PRO Atherton Direct Mount Stem

The PRO Atherton Direct Mount Stem fulfills the NEN-EN 14766 standard (mountain bicycles– safety requirements and test methods). Nevertheless PRO has identified a potential safety issue involving this stem.

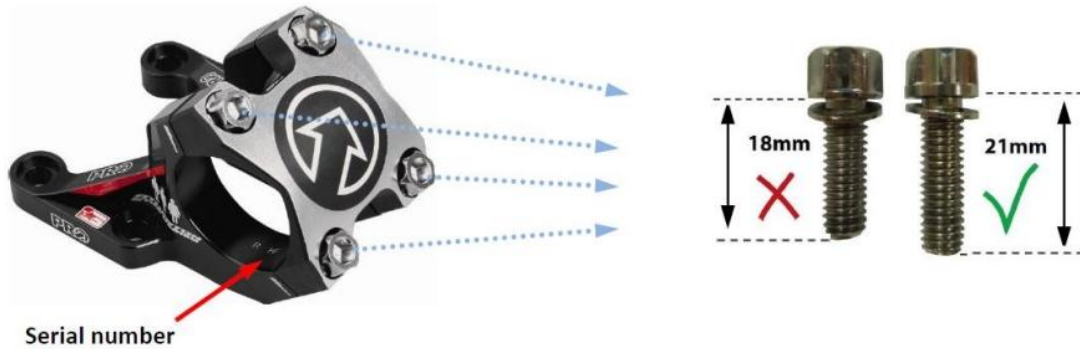
Involved serial numbers are: HH, HJ, HK, HL, IA, IC, ID, IE and IF only when equipped with front clamp bolts with a length of 18mm. Stems with these serial numbers, but equipped with front clamp bolts with a length of 21mm are OK.

In the service instructions the user is instructed to gradually and evenly tighten the bolts of the stem crosswise with a certain tightening torque. If the user does not follow up these instructions a bolt could be pulled out of the thread while riding the bike or the stem may possibly break in case of high impact (e.g. a crash). A broken stem may cause the user to lose control of the bike and fall, which may cause serious injury.

1. check the serial number as indicated in above picture.
 - if your stem contains one of involved serial numbers proceed with (2).
 - if your stem contains a different serial number your stem is not affected
2. check the length of the front clamp bolts as indicated in above picture.
 - if your stem is equipped with 18mm front clamp bolts, please contact your local PRO distributor in order to receive a package to replace your bolts.
 - if your stem is equipped with 21mm front clamp bolts your stem is not affected.

Since all PRO products should meet the highest industry standards, as a precautionary measure and in the interest of putting the safety of its consumers first, PRO decided to undertake a corrective action for all affected stems by supplying longer bolts for the front clamp of the stem.
